Addendum #2

**Bus Maintenance Facility
Twin Valley Community Local School District**

March 9, 2023

CONCRETE PAVEMENT

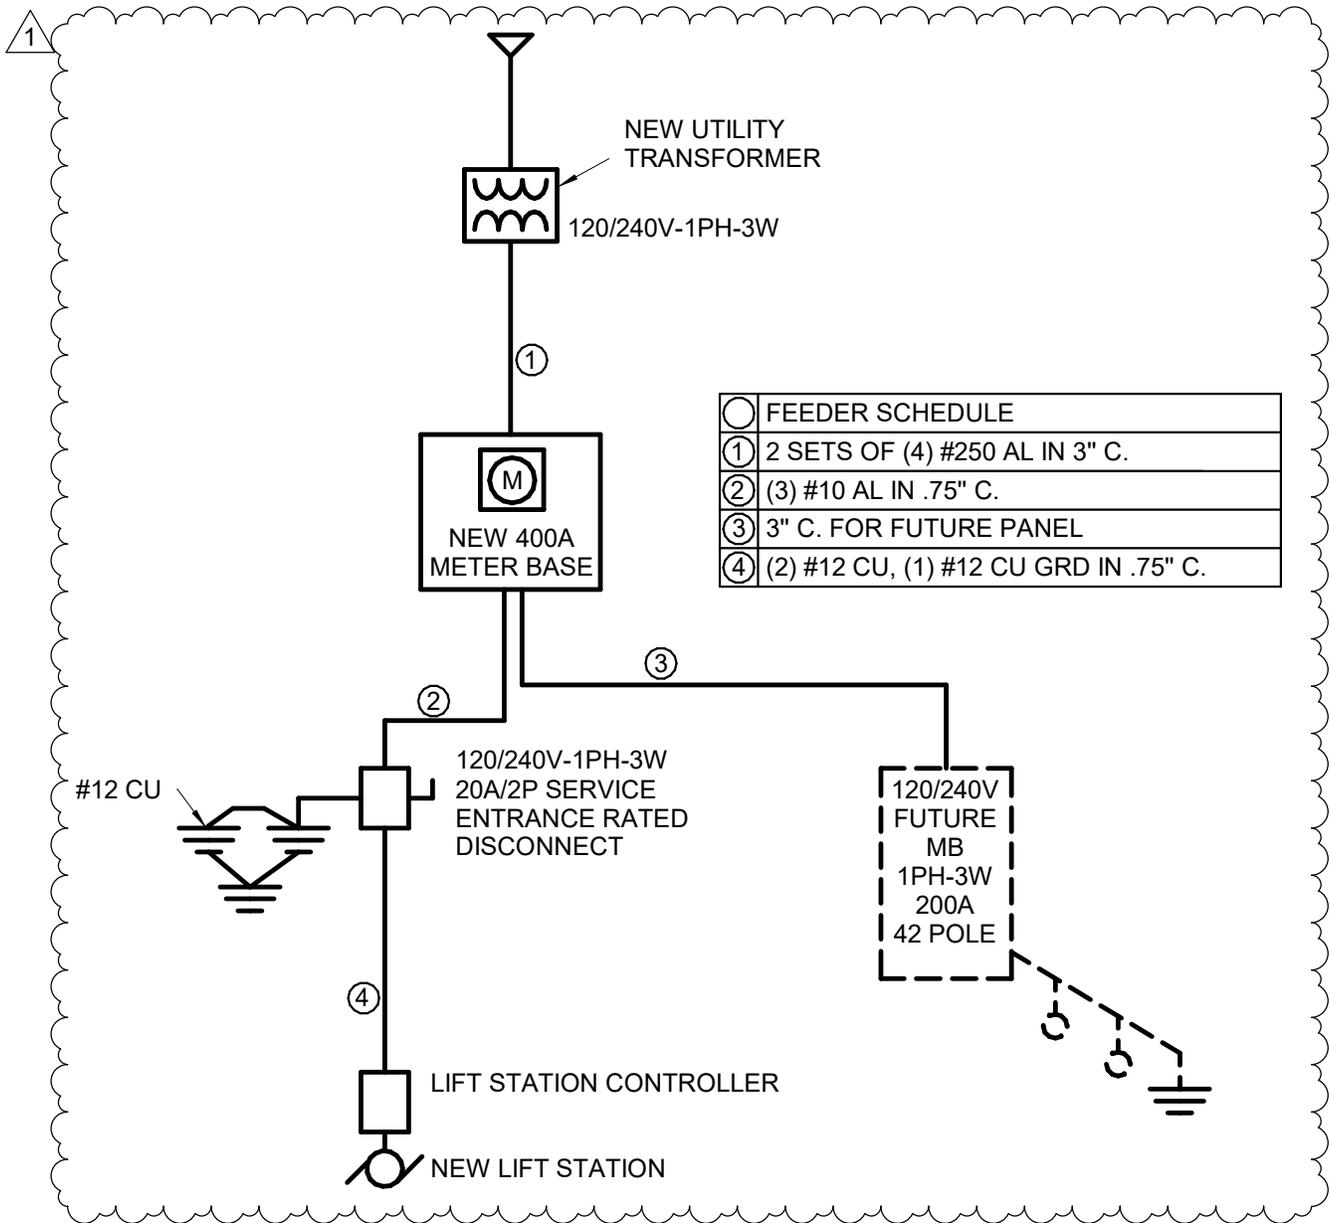
12. Drawing C-5.0: Concrete Pavement Detail; Gravel Drive Section: REVISE details as per the attached sketch from Burkhardt Engineering.
13. Drawing A1.5, Mezzanine Framing Plan / Joist Spacing Plan: Contractor Option: Contractor may provide 16" deep TJI floor joists in lieu of [2] 14" deep TJI joists provided that the 16" deep TJI joists meet the 125 PSF live load requirement for the mezzanine. The joist spacing shall remain as outlined to provide pathways for ductwork as diagramed. If this option is selected by the Contractor, the stair framing shall be altered for the new floor to floor height. Maximum riser height is 7".

- A – 7" PORTLAND CEMENT CONCRETE (3500 PSI)
- B – 6" CRUSHED AGGREGATE BASE ODOT ITEM 304
- C – ODOT ITEM 204 SUBGRADE COMPACTION AS PER GEOTECH SPECIFICATIONS

- CONTRACTOR SHALL VERIFY WITH GEOTECHNICAL ENGINEER AND OWNER THAT SECTION IS SUITABLE.
